PROJECT: **HENGAM FERTILIZER PROJECT**

TITLE: **MACHINE MONITORING DIAGRAM**
CO2 COMPRESSOR (11-C-101)

| SHT: 1 OF 1 | PIDEC PROJECT NO.: 1208 | PIDEC DWG. NO.: VD-1208-301B-PID-405 | |

① TYPICAL SHAFT VIBRATION

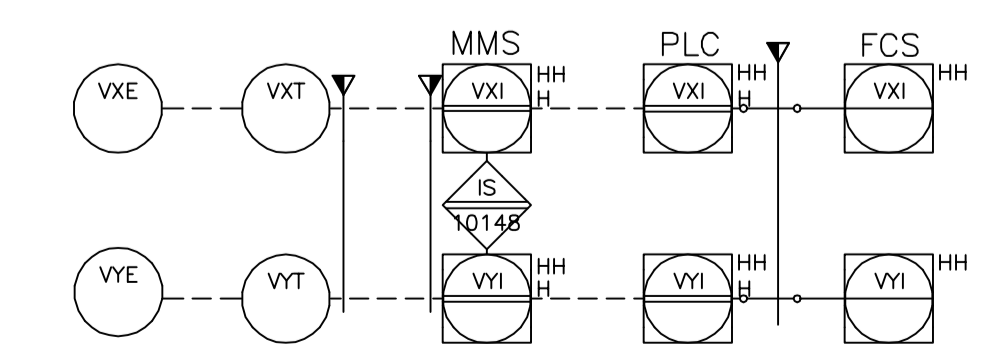
As per owner comment on similar document for process air compressor (PID-105), one line shall be considered in center instead of two for FCS Legend, please correct mentioned document

② TYPICAL SHAFT POSITION

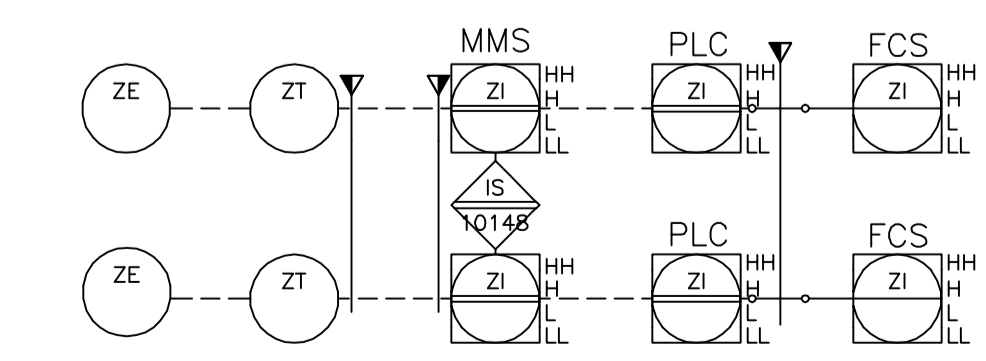
As per owner comment on process air compressor(PID-105), it has been shown "typical shaft vibration" that should be revised same as below to "TYPICAL SHAFT POSITION". Please correct mentioned document

1.IS-10148 is activated in case of HH position as 2oo2
2.Alarm position is activated in case of H position as 1oo2

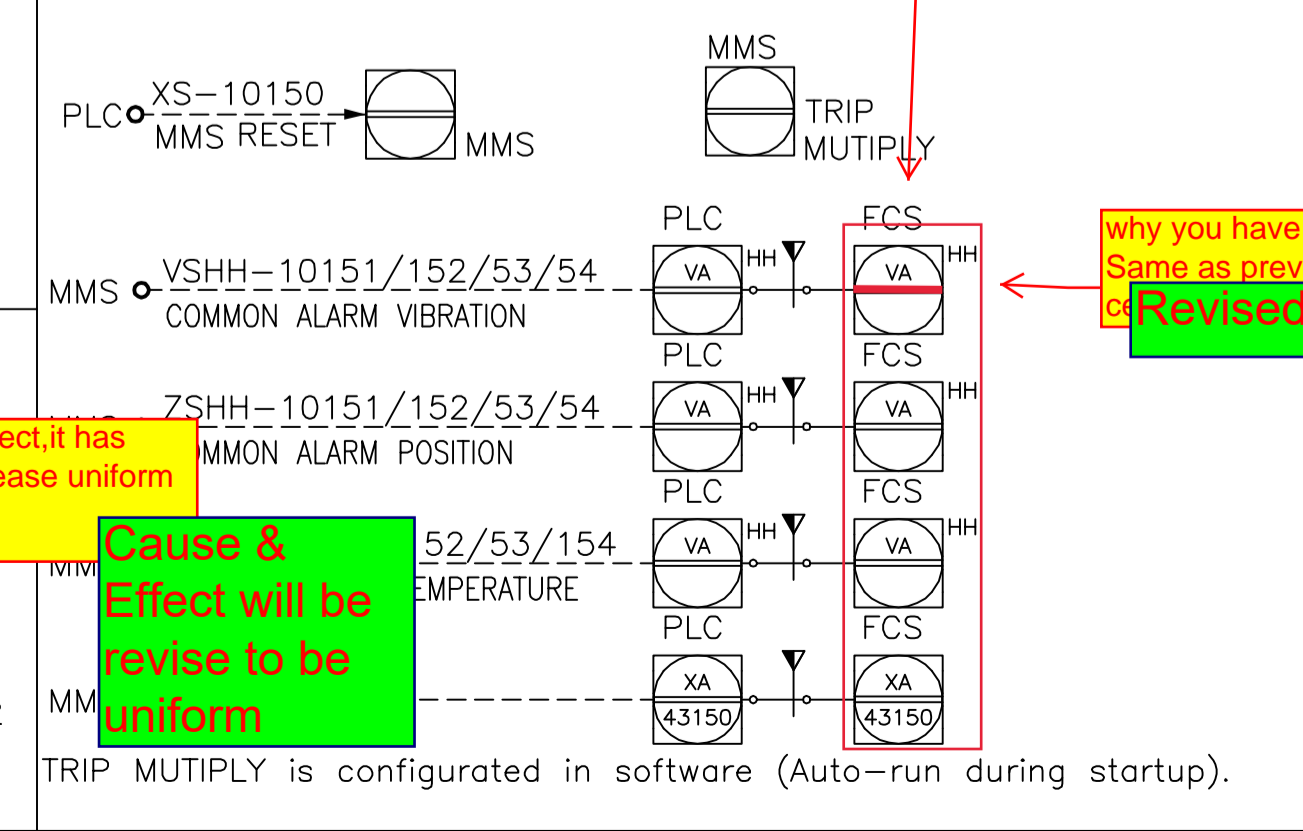
Cause & Effect will be revise to be uniform

why you have changed FCS LEGEND in this issue? Same as previous revision, FCS shall have one circle in correct
